Addendum No.1
to
CONSTRUCTION DOCUMENTS
for

May 21, 2025
2023159.00

NCISD New District Administration Building
21330 Valley Ranch Parkway
New Caney, TX. 77357
May 20, 2025

2 STAIR FRAMING PLAN
1/4" = 1'-0"

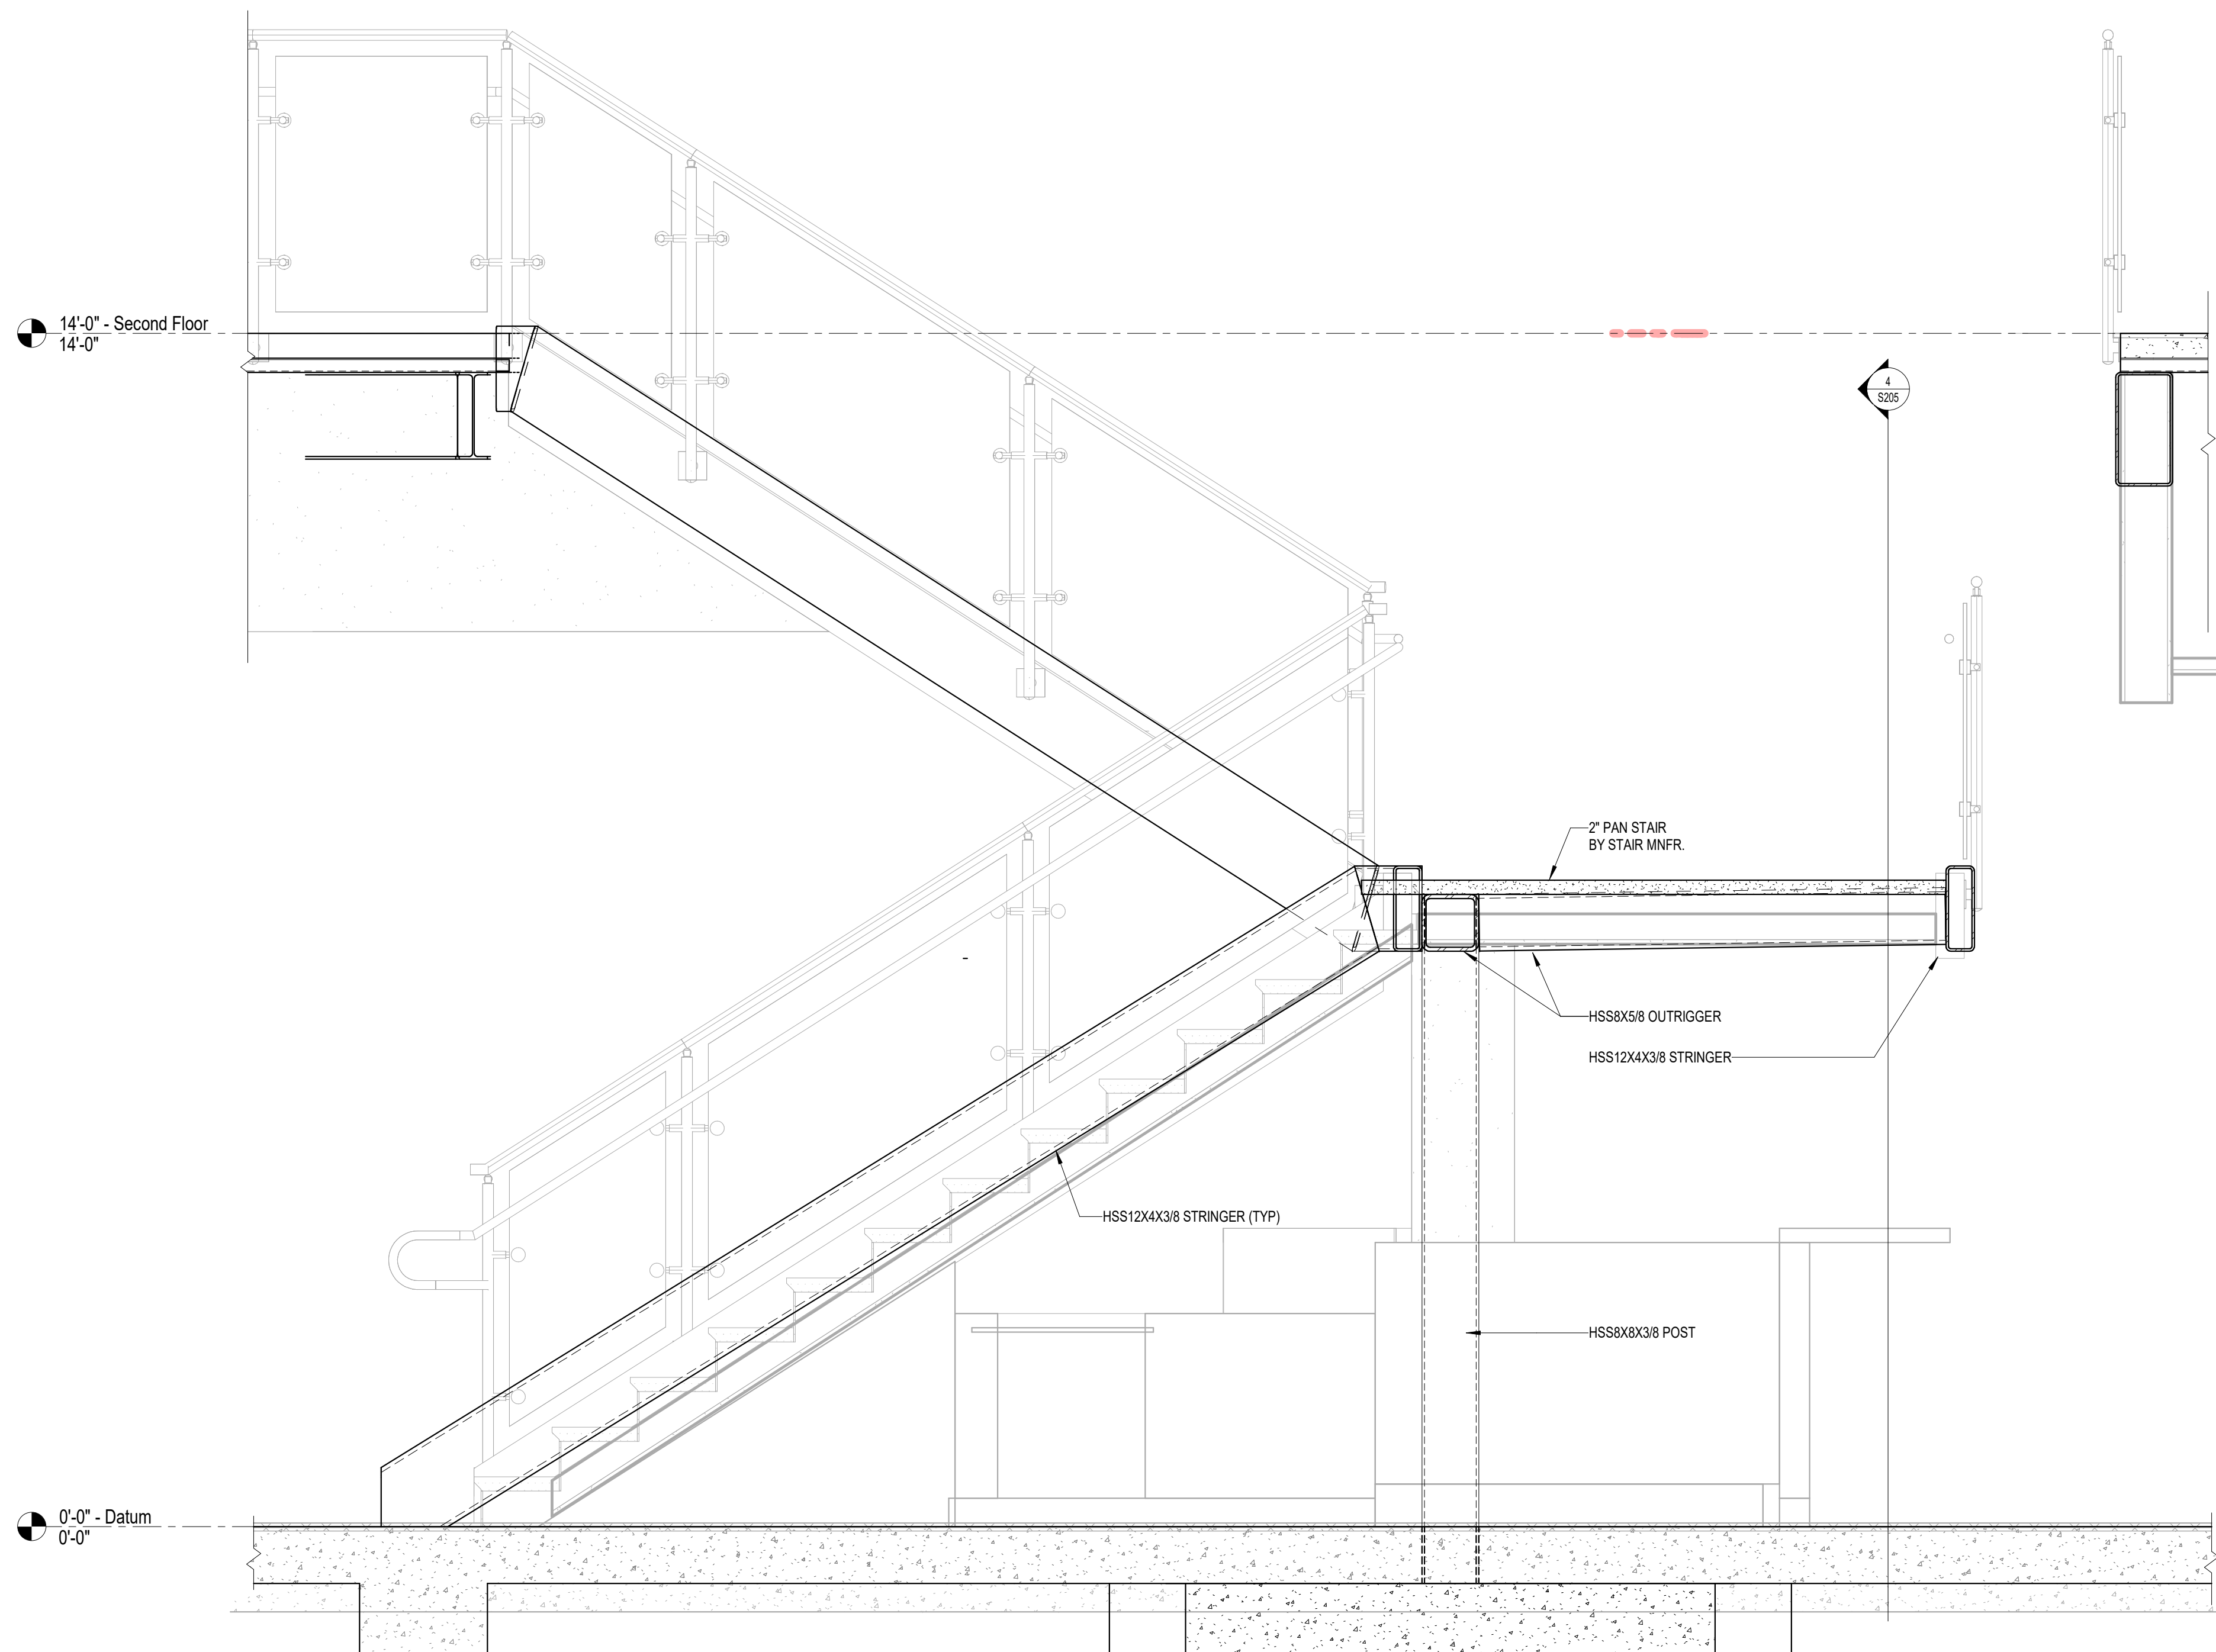
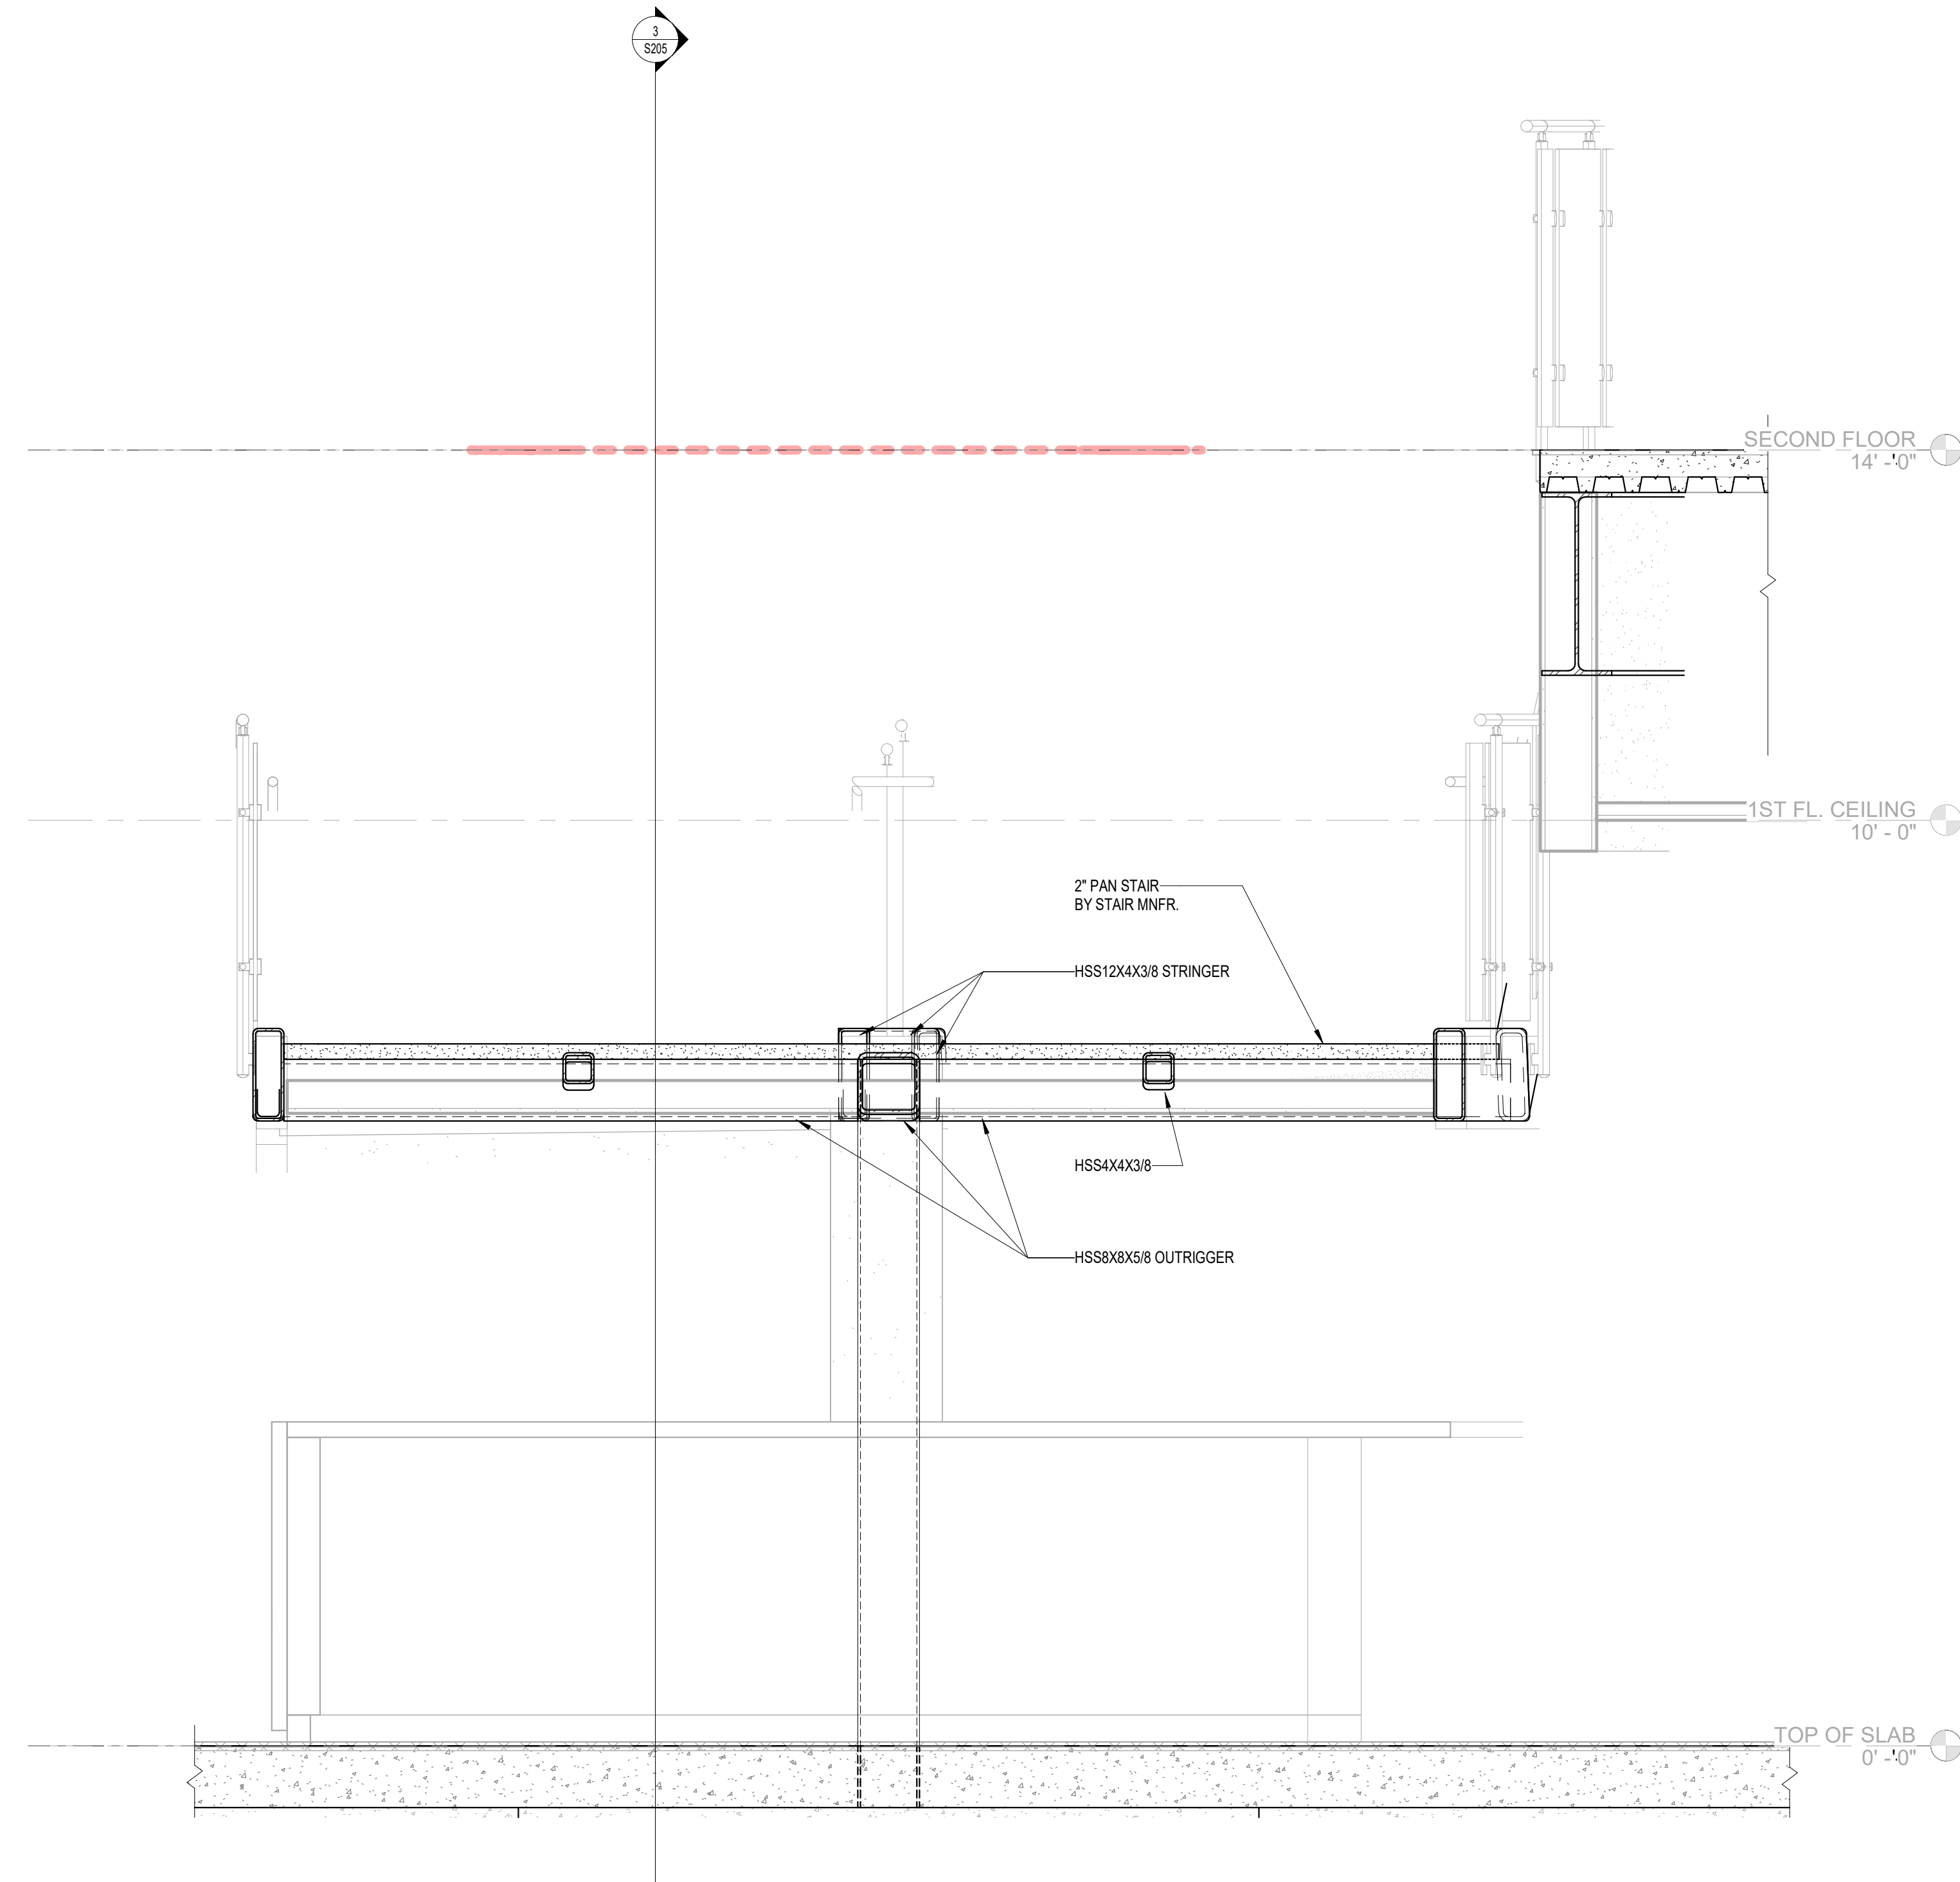
Item No. 10 **Sheet S205:**

- a) Delegated Design clarification comment added.

P-127

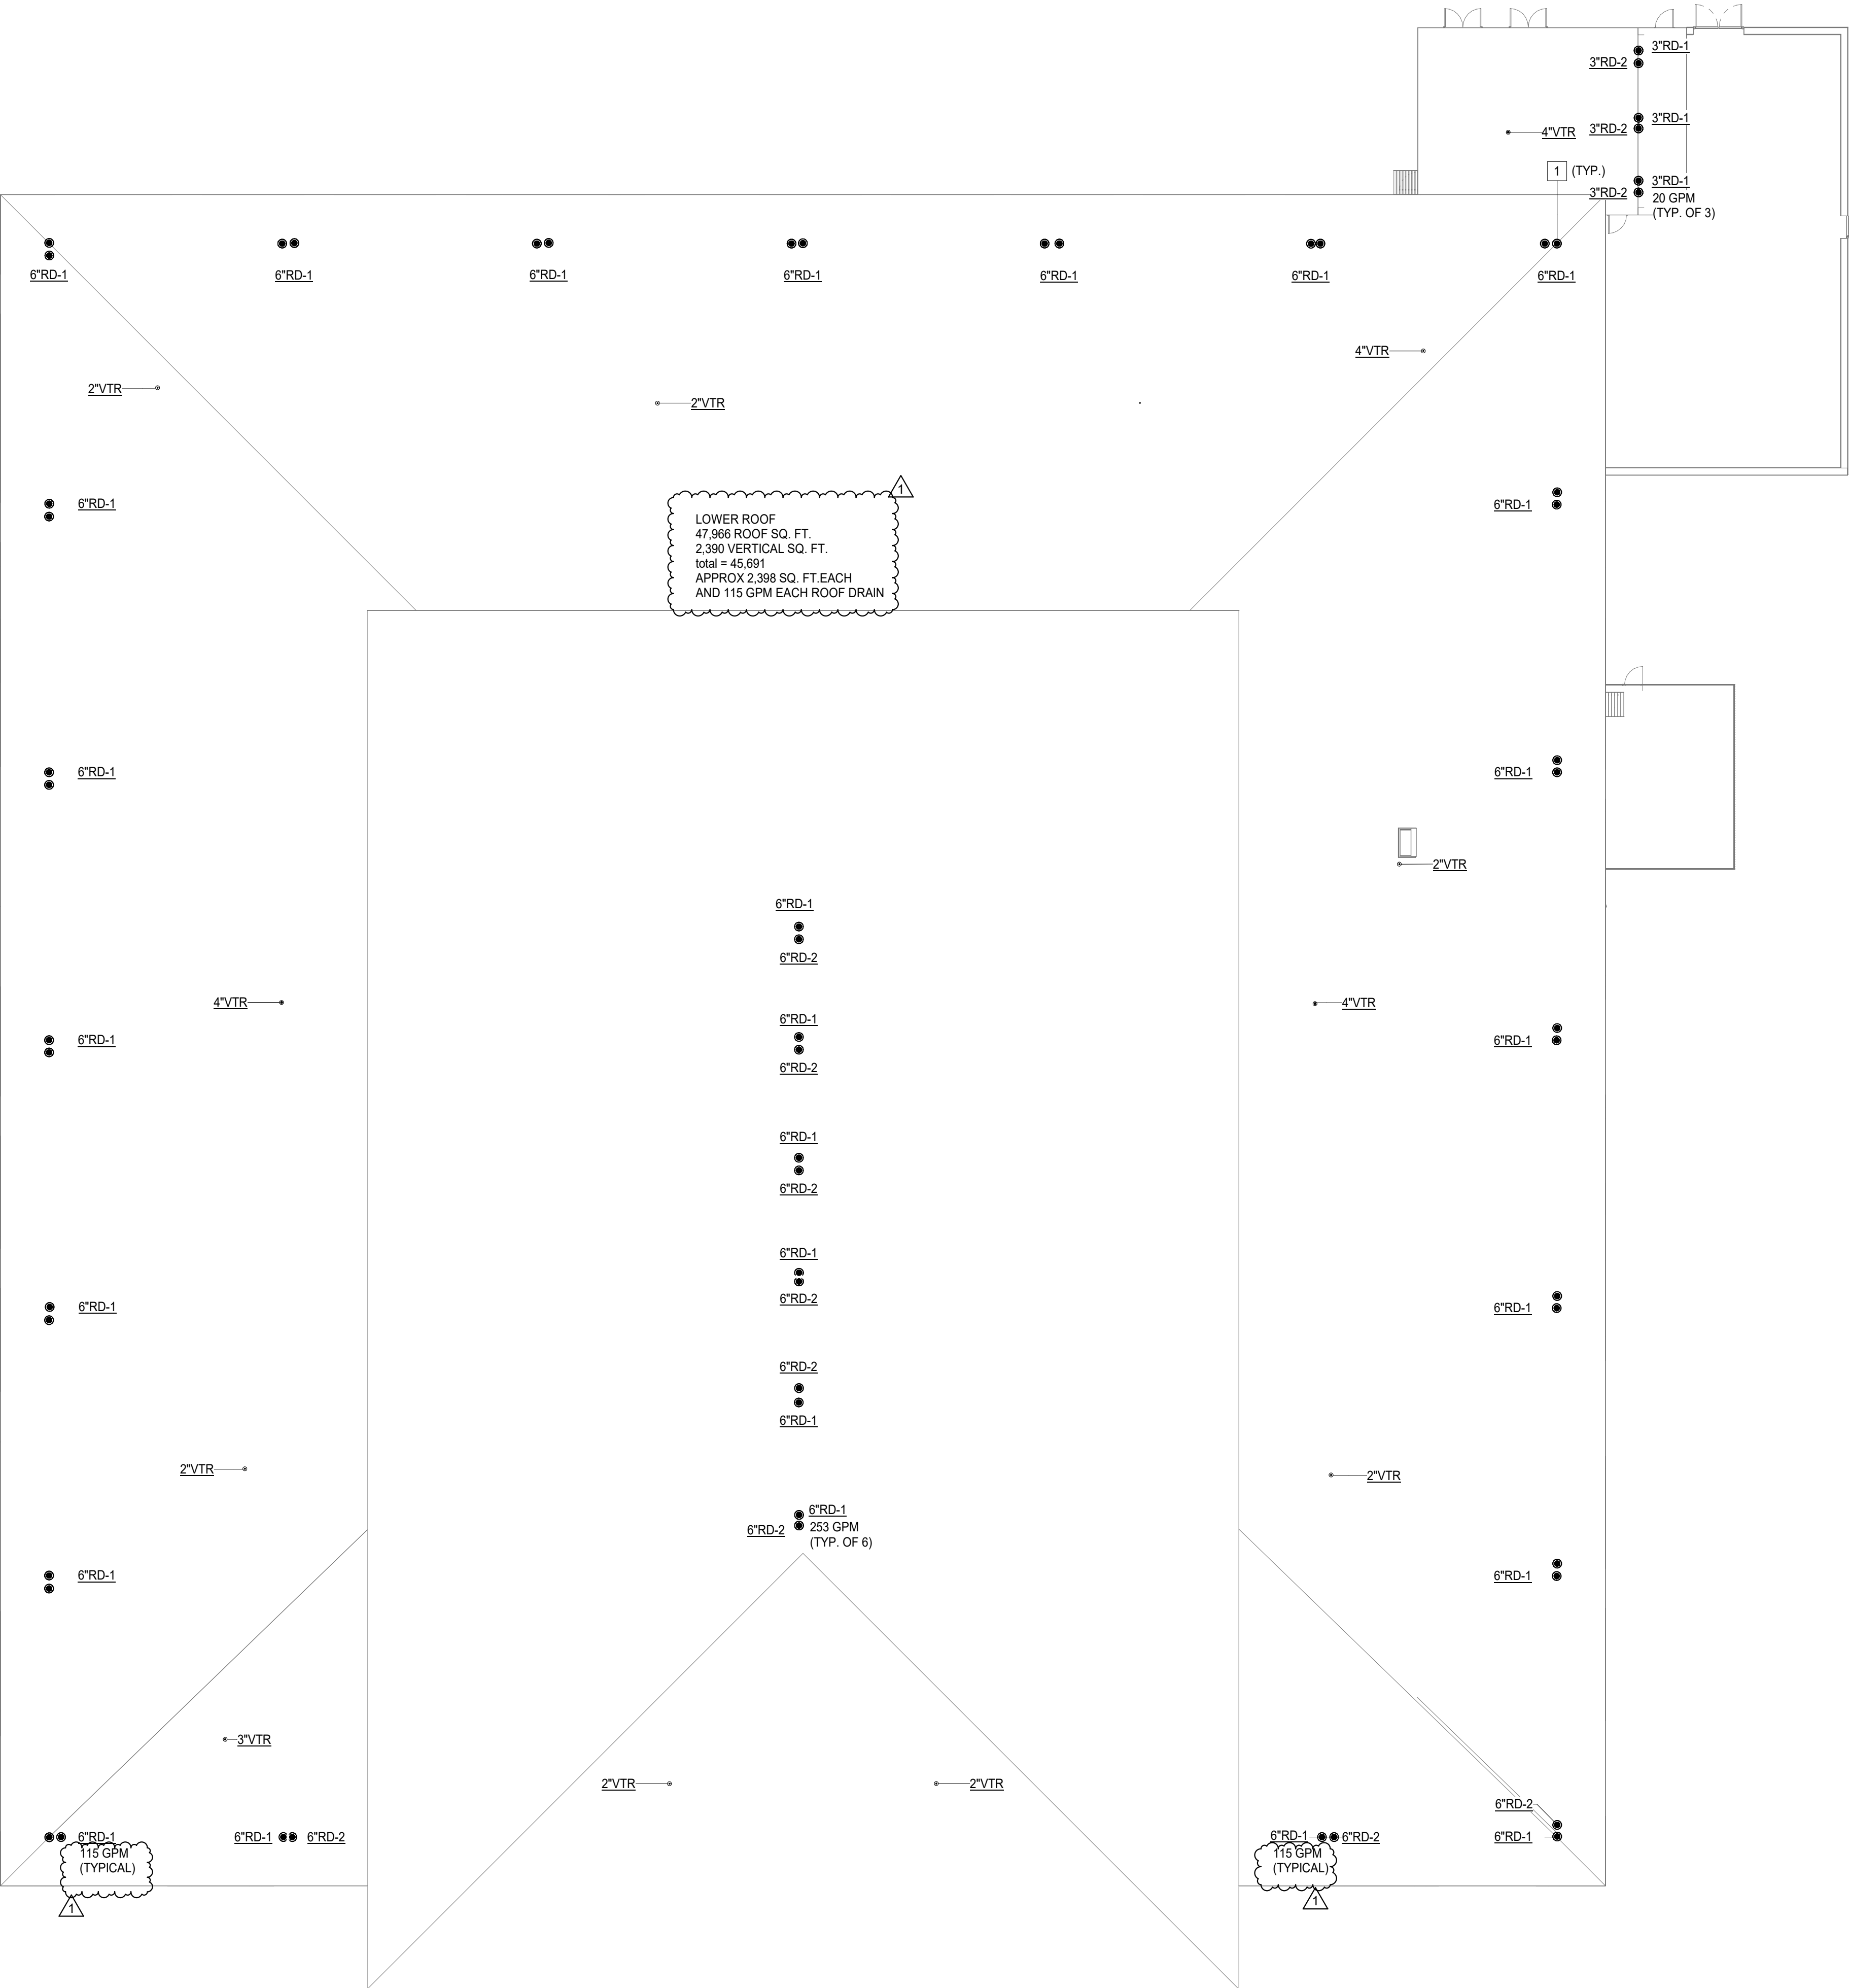
1. SHEET P-100 – PLUMBING SITE PLAN
 - a. Refer to revised sheet for addition of Storm GPM at outfalls.
2. SHEET P-127 – PLUMBING ROOF PLAN
 - a. Refer to revised sheet for updated roof areas and GPM flows.
3. SHEET T-100.2 - TECHNOLOGY ENLARGED SITE PLAN
 - a. Revise (2) cameras orientation as shown.
